Access Compliance Report

Public Rights-of-Way

(Curb Ramps)

Intersection ID: 51794	Main Street: SUTTONVIEW_DR	Cross Street: BRADY_DR	Location: S
ADA ID: 7BF6F9FFBA3A	Ramp Type: PerpDiag	Initial Pass/Fail: Fail	Overall Compliance: No
Codes/Mitigation Info/Possible Solution		Field Measurements/Component Compliance

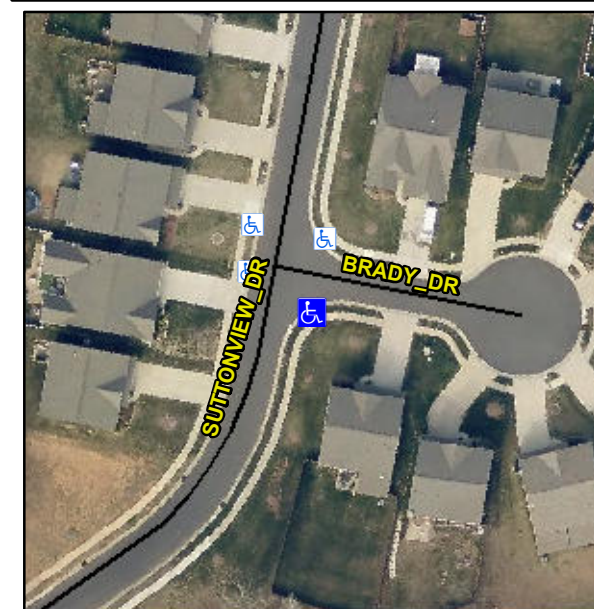
Not Found, R304.5.1, R304.5.3

Compliance	Description	Data	Compliance	Description	Data
N/A	Ramp Length (in)	48.0	Yes	Ramp Slope (%)	7.0
No	Ramp Width (in)	46.0	No	Ramp XSlope (%)	4.1
N/A	Flare Type LT	N/A	N/A	Flare Type RT	N/A
N/A	Flare Slope LT (%)	N/A	N/A	Flare Slope RT (%)	N/A
N/A	Flare Traversable LT?	N/A	N/A	Flare Traversable RT?	N/A
N/A	Landing Length (in)	N/A	N/A	DWS Provided?	N/A
N/A	Landing Width (in)	N/A	N/A	DWS Contrast?	N/A
N/A	Landing Slope (%)	N/A	N/A	DWS Length (in)	N/A
N/A	Landing X Slope (%)	N/A	N/A	DWS Full Width?	N/A
N/A	Landing Curb? (Y/N)	N/A	N/A	DWS Offset (in)	N/A
N/A	Shared Landing?	N/A			
N/A	Gutter Ponding?	N/A	N/A	Gutter Slope (%)	N/A
N/A	Gutter Lip Ht (in)	N/A	N/A	Gutter X Slope (%)	N/A
N/A	Painted X Walk1?	No	N/A	Painted X Walk2?	No
	X Walk 1 Direction	To NE		X Walk 2 Direction	To NW
N/A	X Walk 1 Width (in)	N/A	N/A	X Walk 2 Width (in)	N/A
	X Walk 1 Slope (%)	2.1		X Walk 2 Slope (%)	4.8
	X Walk 1 X Slope (%)	4.6		X Walk 2 X Slope (%)	0.2

Remove & Replace Curb Ramp With Two New Directional Ramps or Equivalent.
